CONSTRUCTION SUMMARY

120 - 1 - 38-4 Elev.B VIVALDI

The Vivaldi

Elevation A - 2,518 sq.ft. | Elevation B - 2,518 sq.ft.

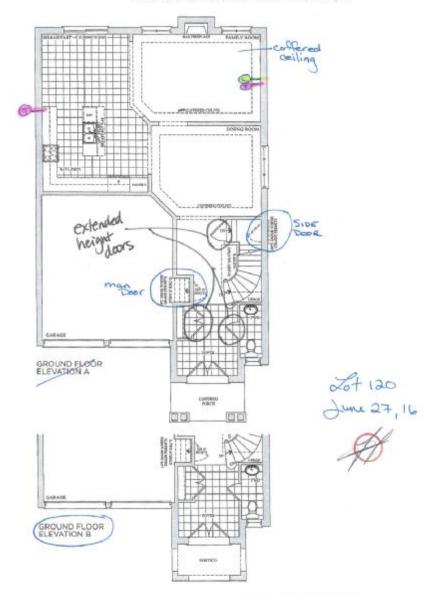
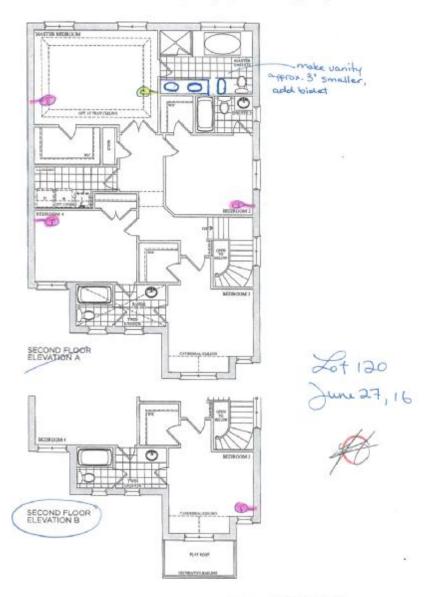
Inv.606	1 - KITCHEN: INSTALL KITCHEN CABINET STRIP VALANCE LIGHTS (UNDER CABINETS) - ROUGH - IN - DOES NOT INCLUDE (AND REQUIRES) KITCHEN UPGRADE PRICING
Line12013	Note:
27Jun16 / 27Sep16	
Inv.606	1 - MASTER ENSUITE: DELETE THREE FEET OF THE MASTER ENSUITE VANITY TO ACCOMODATE A BIDET. VANITY TO STILL HAVE DOUBLE SINK. SEE SKETCH
Line12014	Note:
27Jun16 / 27Sep16

Inv.606	1 - MASTER ENSUITE: DELETE THREE FEET OF THE MASTER ENSUITE VANITY TO ACCOMODATE A BIDET, VANITY TO STILL HAVE DOUBLE SINK, SEE SKETCH
Line7441	Note:
27Junt6 / 27Sep16	
Inv.606	I - MASTER ENSUITE: INSTALL BIDET - COMPLETE (INCLUDES FIXTURE)
Line7442	Note:
27Jun16 / 27Sep16	
nv.606	1 - BASEMENT: INSTALL ROUGH-IN - 3PC BASEMENT ROUGH-IN, AS PER PLAN
Line7445	Note:
27Jun16 / 27Sep16

Casement Windows

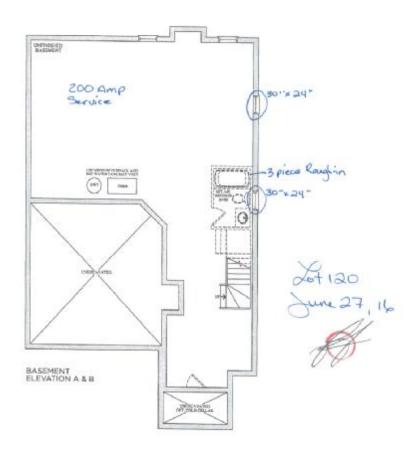
Inv.606	2 - BASEMENT: INSTALL TWO (X2) BASEMENT WINDOWS - UPGRADE EXISTING BASEMENT WINDOW TO 30 INCH X 24 INCH - MAY REQUIRE INSTALLATION OF WINDOW WELL
Line7443	Note:
27Jun16 / 27Sep16

2 x 30"x24"
